M42 Junction 6 Development Consent Order (TR010027) - Non-material change request

Change 1: Proposed change to the southern extent of the Limit of Deviation for Work No. 63 (Severn Trent Aqueduct)

Change 2: Attenuation Tank Relocation (Work No. 34)

Change 3: Parcels of land to be removed from the Order Limits

Appendix A – Design Information by Severn Trent Water

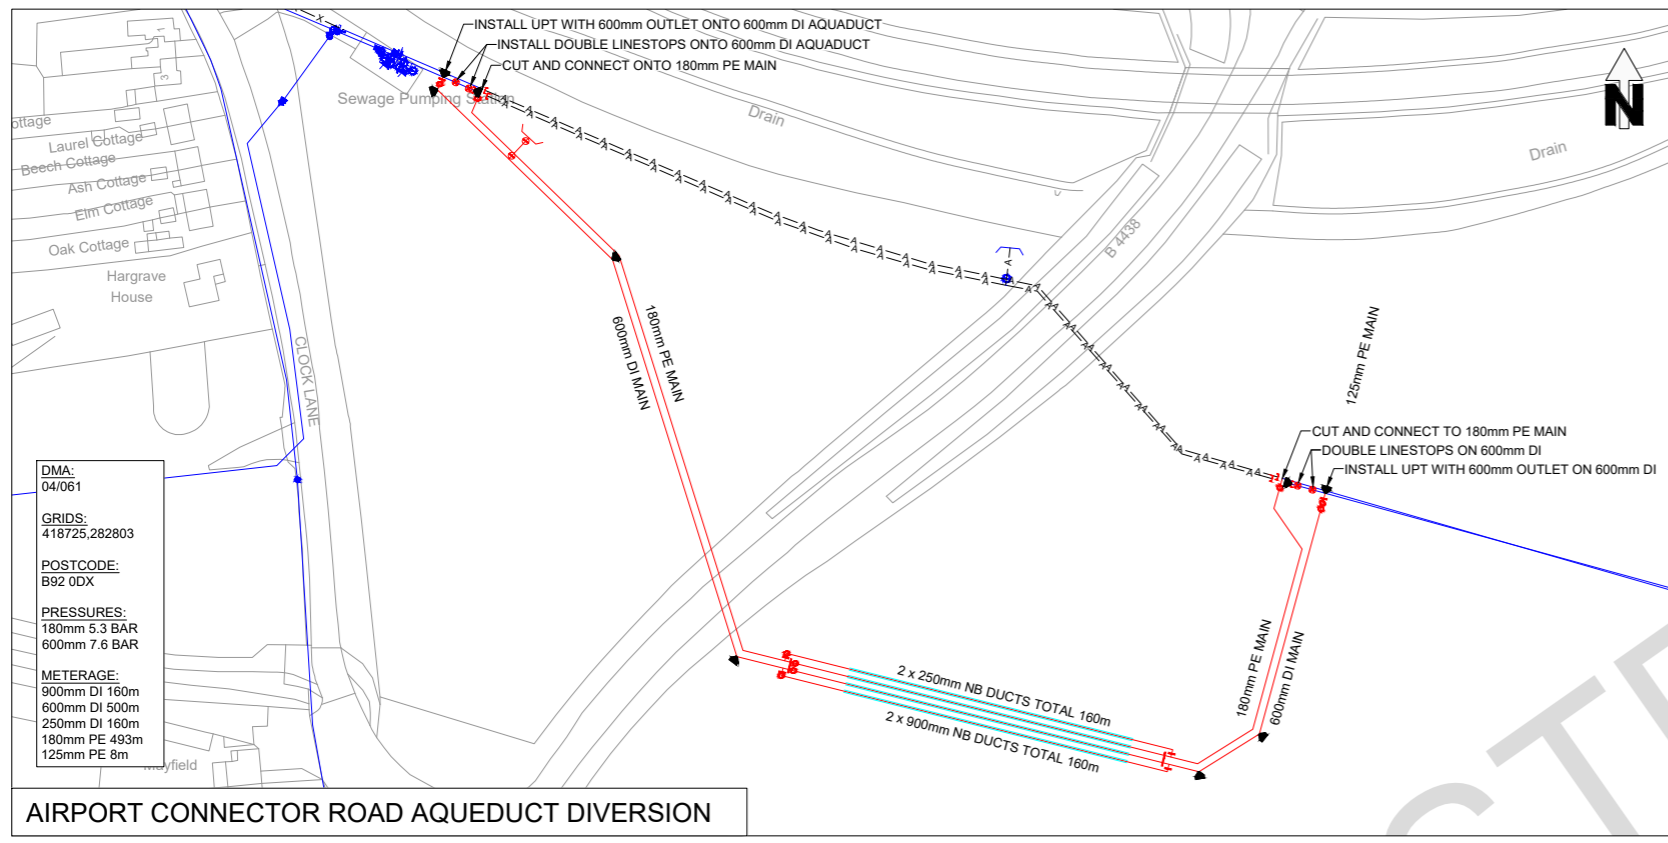
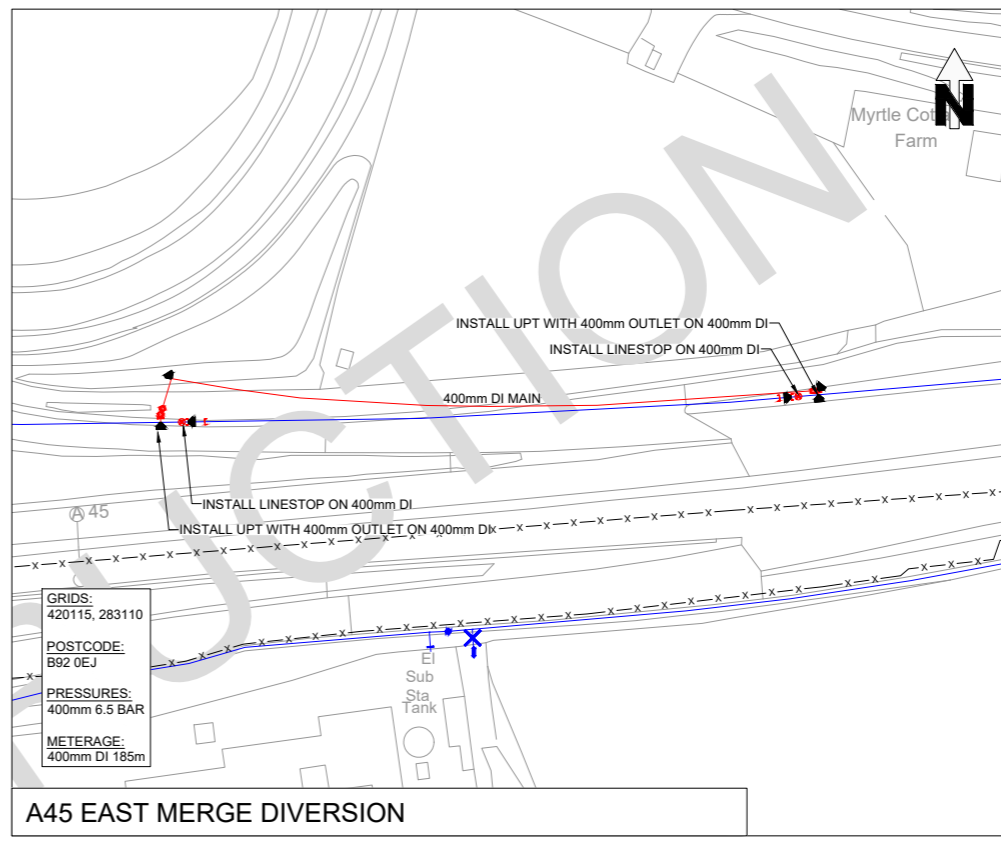
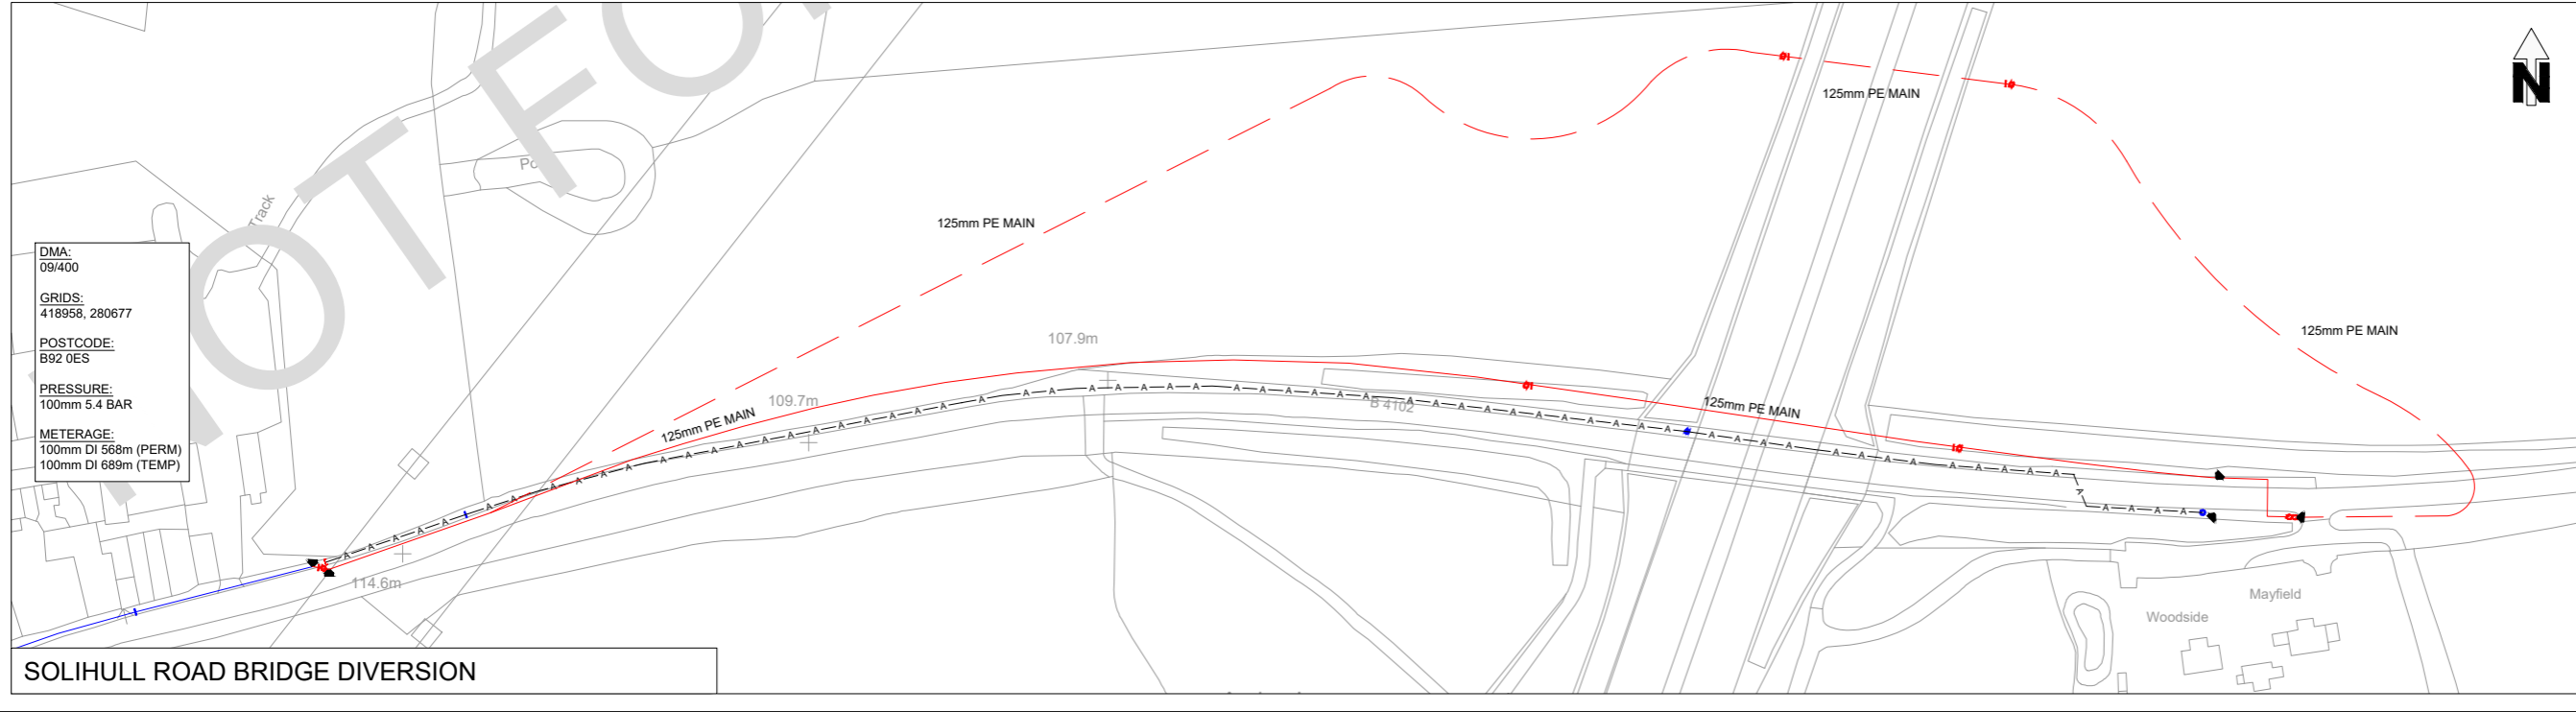
Design information provided by STW (see **Appendix A**) shows that its preferred route for the aqueduct diversion (Work No. 63) would be further south than that envisaged in the Scheme to allow greater ease of maintenance once the Scheme is operational.

Appendix B – Revised Works Plan Sheets 3 and 4

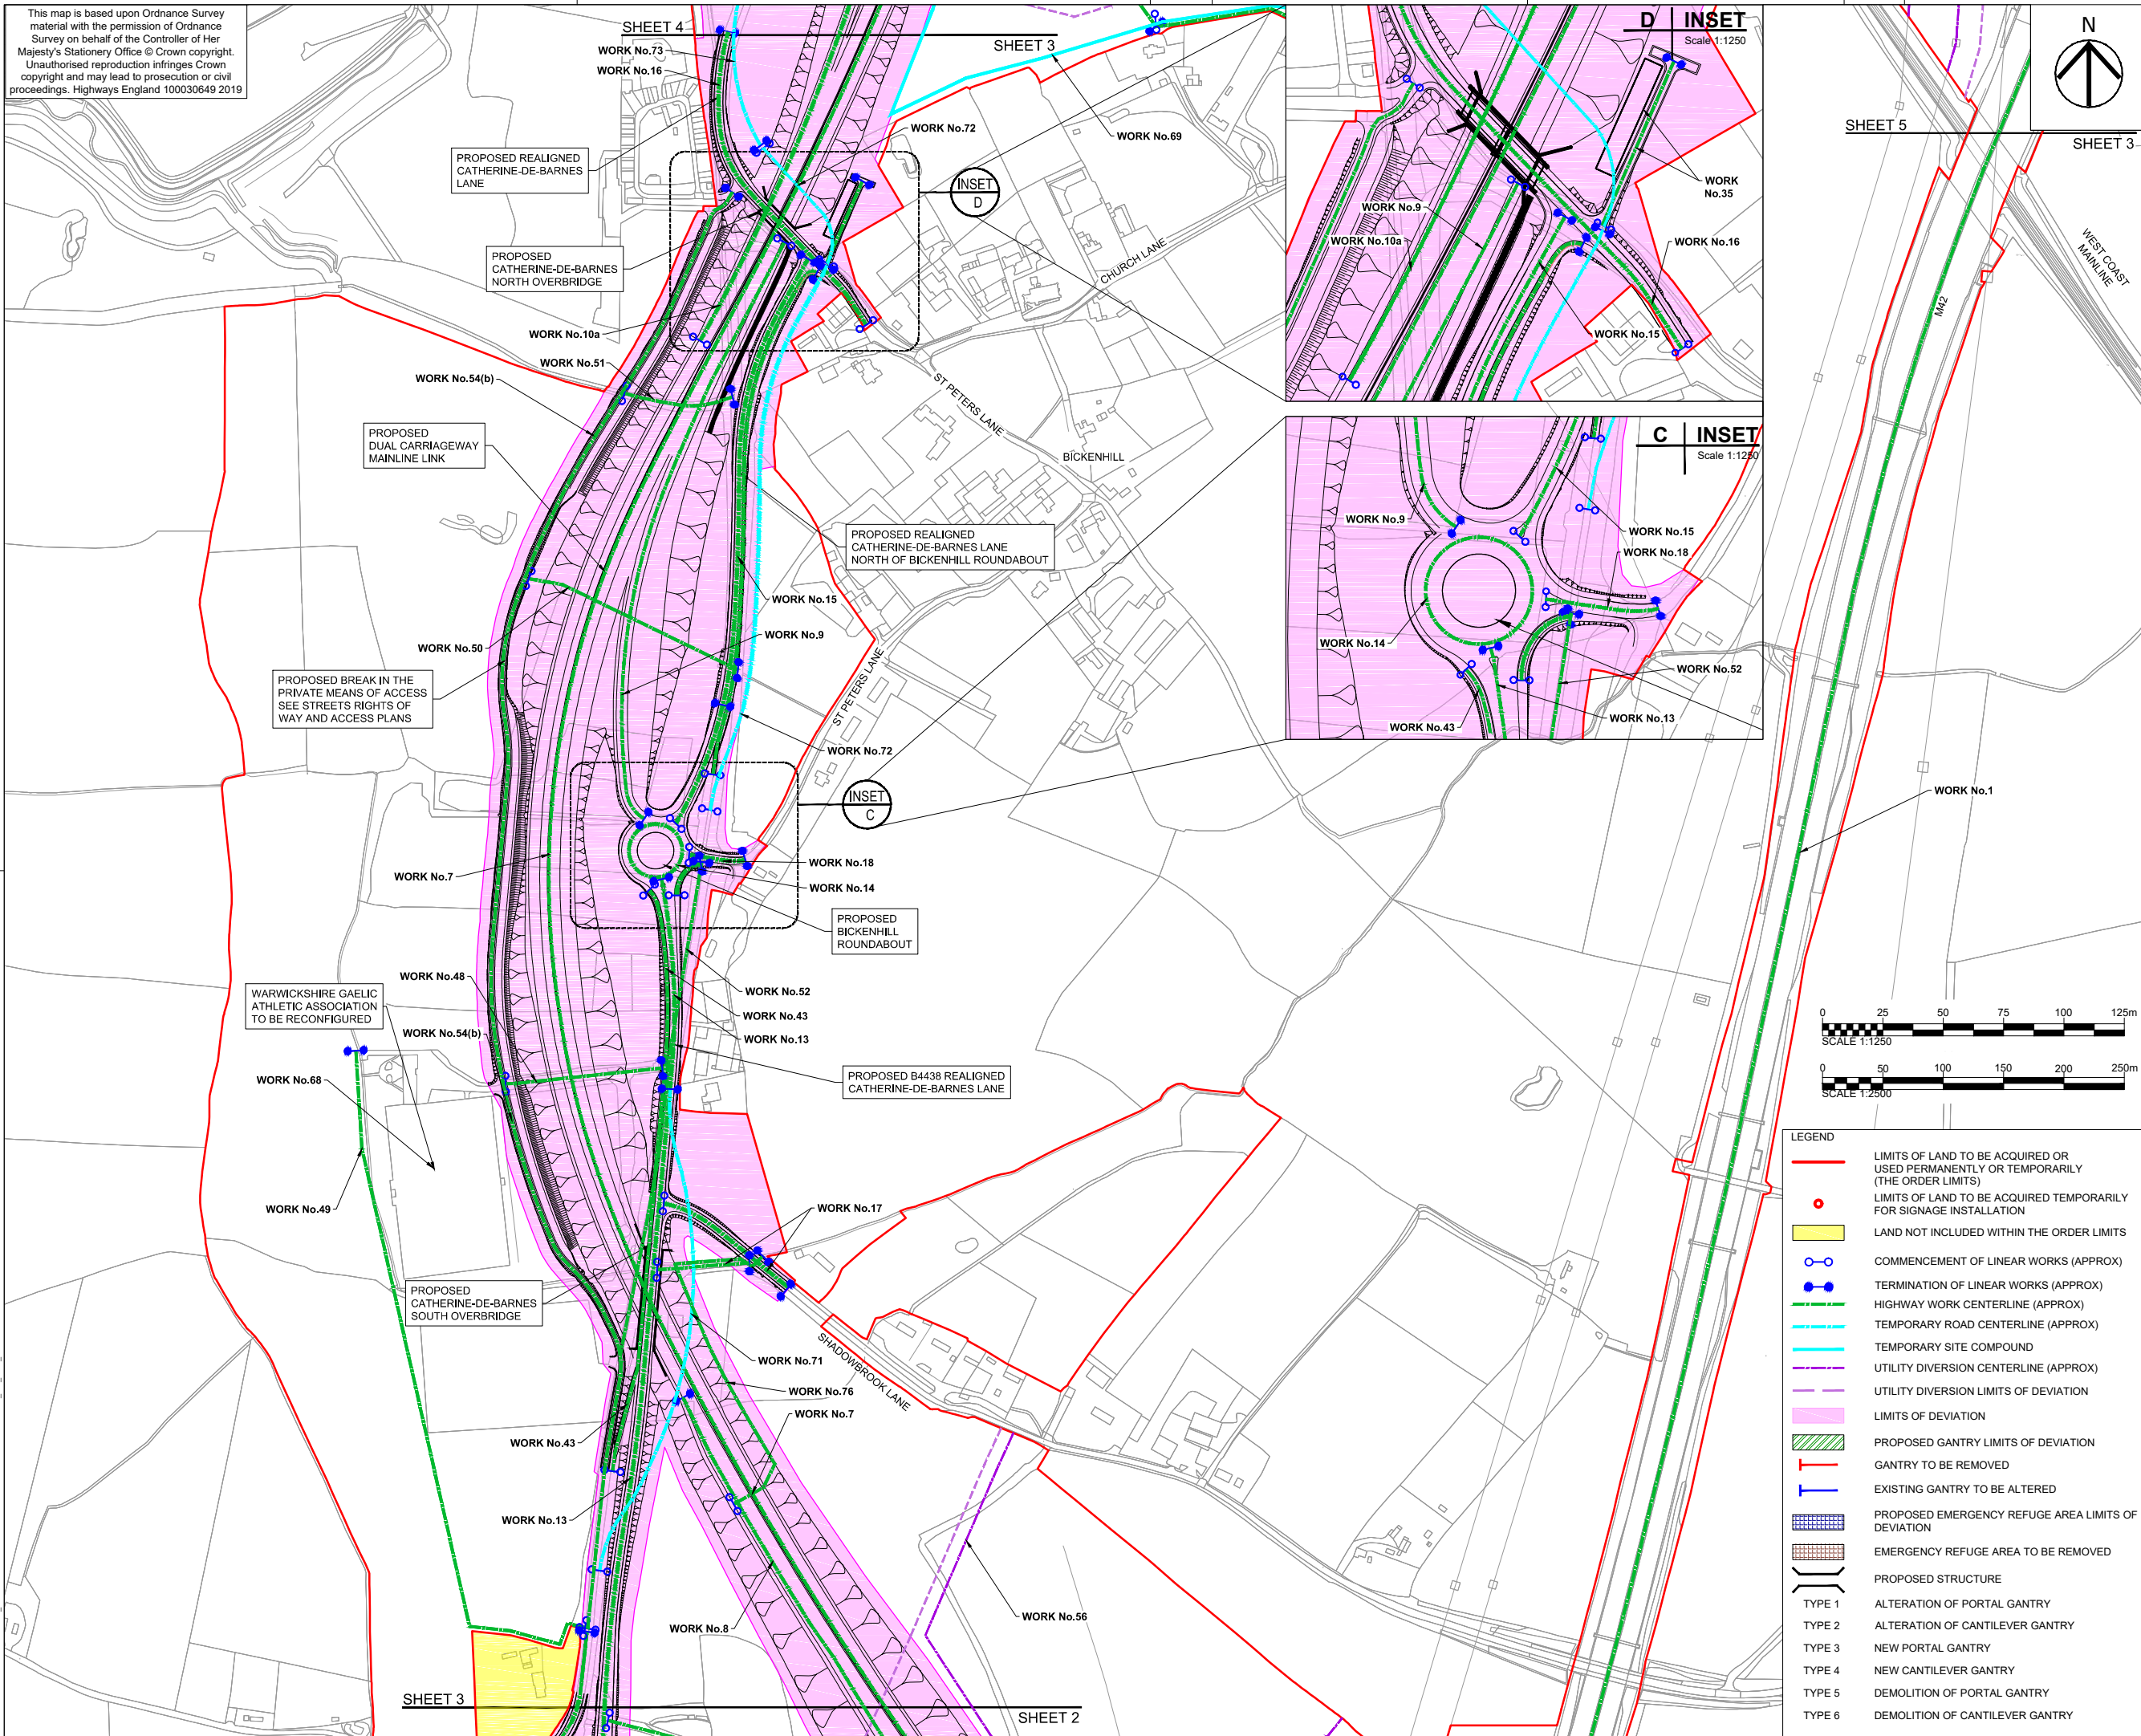
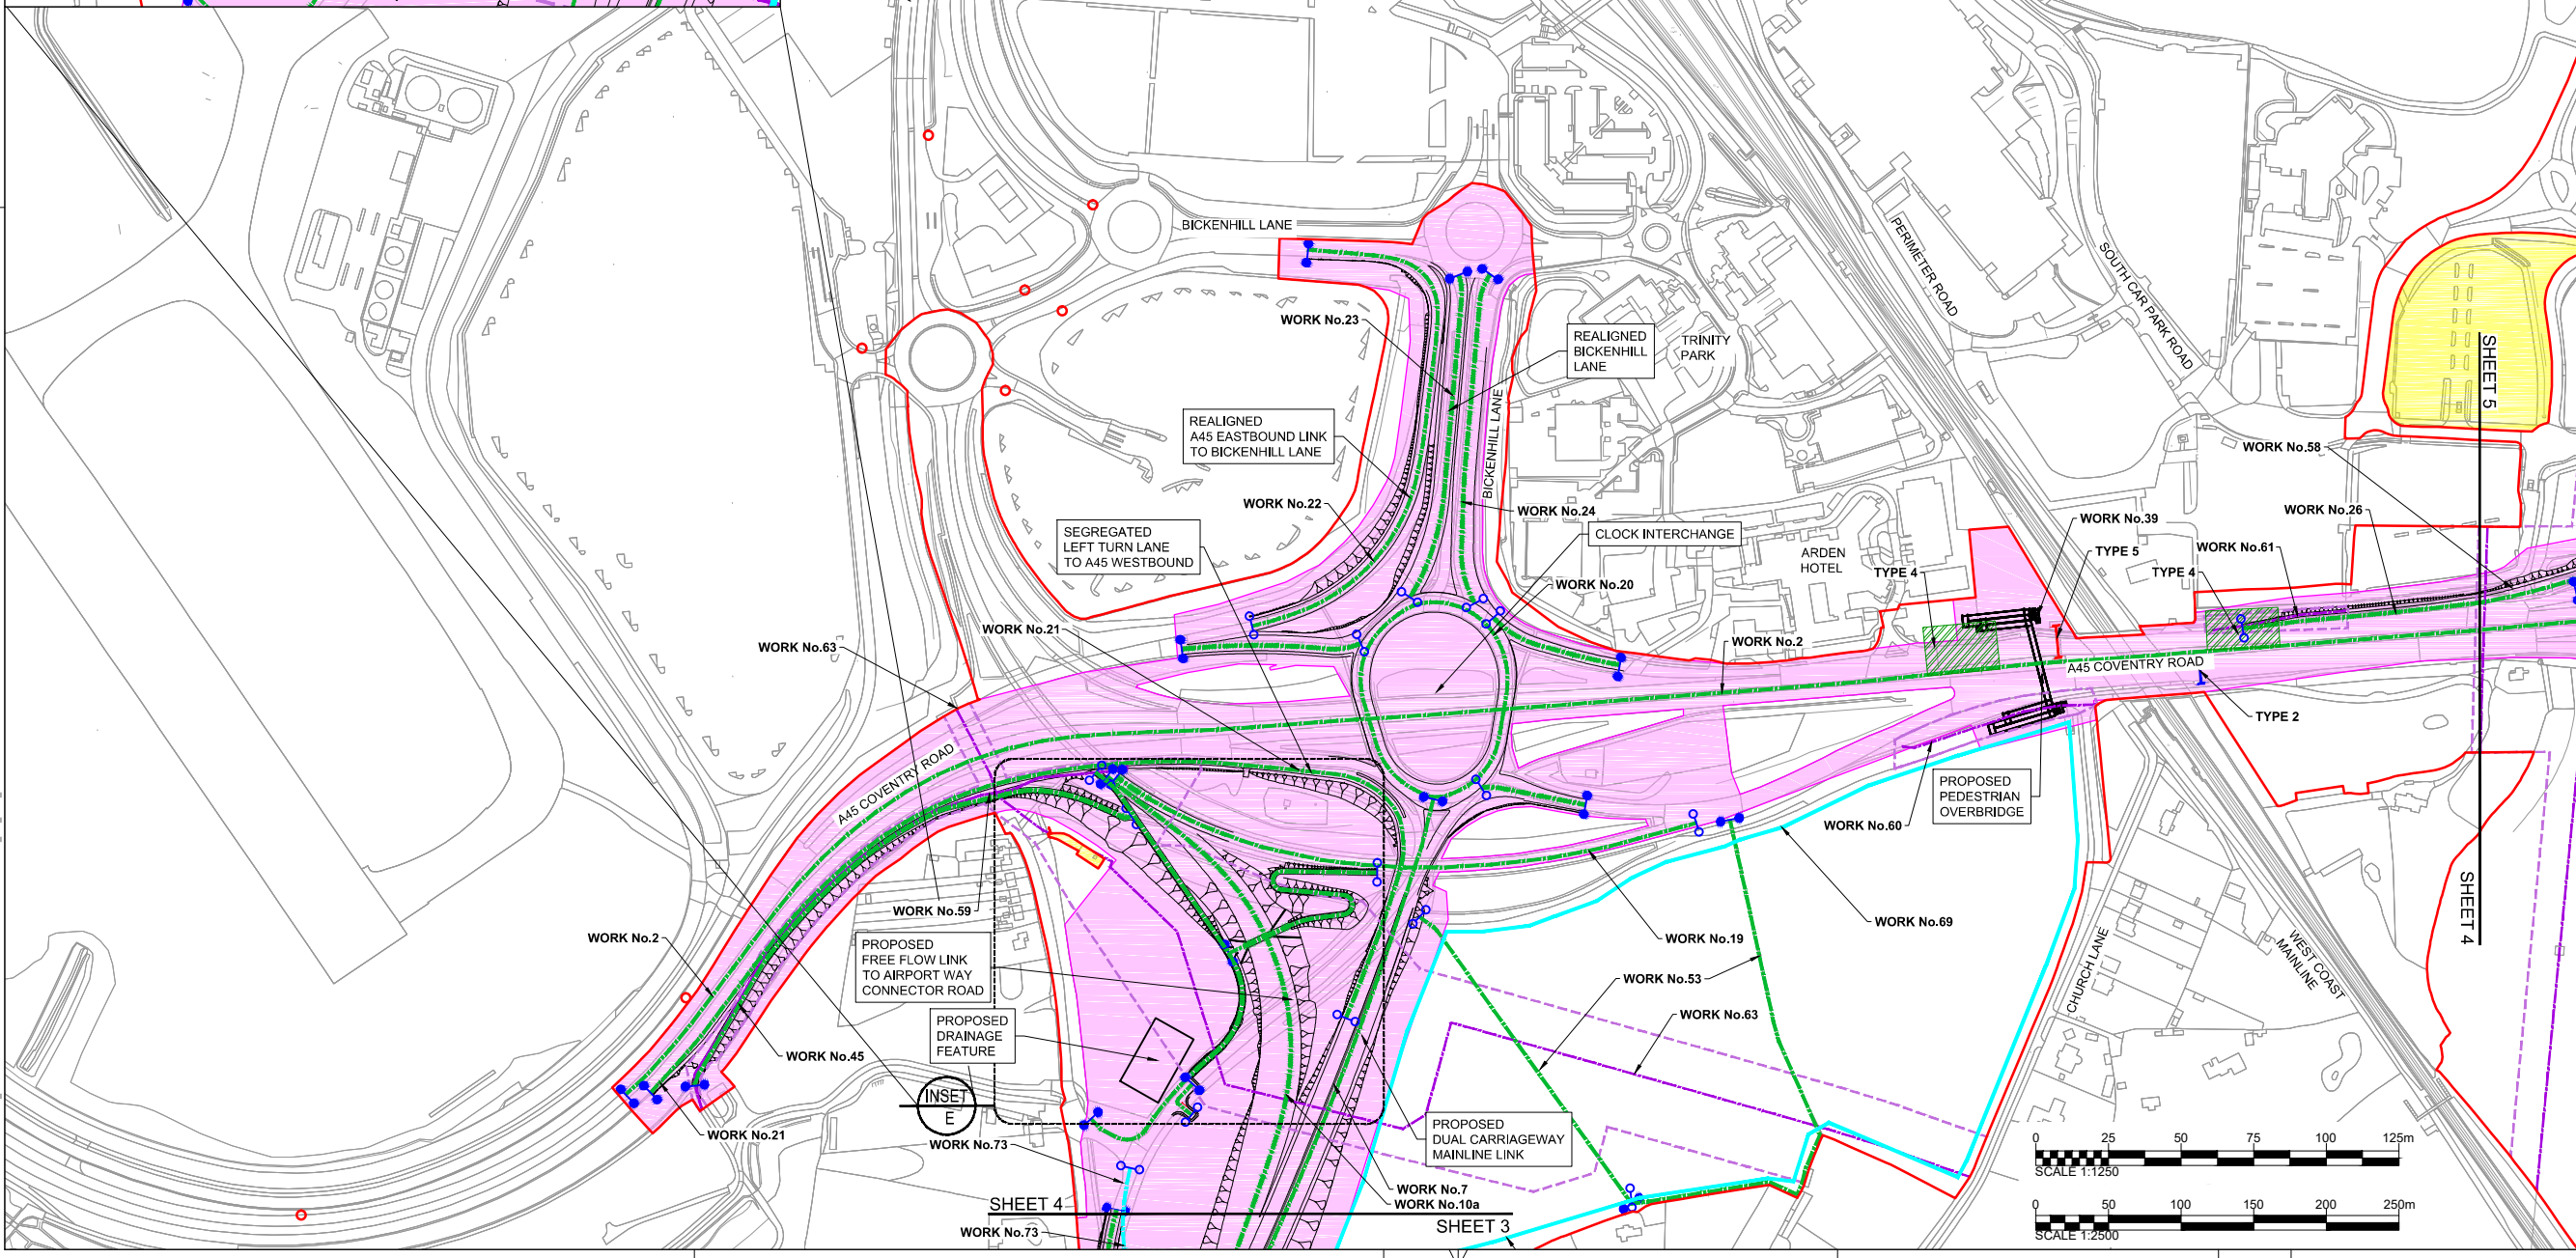
This would necessitate the southern extent of the Limit of Deviation (LoD) for Work No. 63 (see **Appendix B**) to move further south from parcel 4/4w, into parcel 4/4k (see **Appendix C**). Both parcels have the same landowner. Parcel 4/4k is already proposed to be used temporarily for the diversion of Western Power Distribution's apparatus, with permanent rights being sought under the DCO "*to construct, operate, access and maintain diversions to existing utilities apparatus and equipment*" [**APP-018 / Volume 4.1**].

Although STW is a statutory utility, and so the diversion is already covered by the wording of Schedule 7, the Applicant proposes to alter this description of this right in the dDCO so that it refers explicitly to Work No. 63 as well.

This proposal would not require additional land take beyond the existing Order limits and, as mentioned above, dialogue has already begun with the land owner in this location about this proposal.
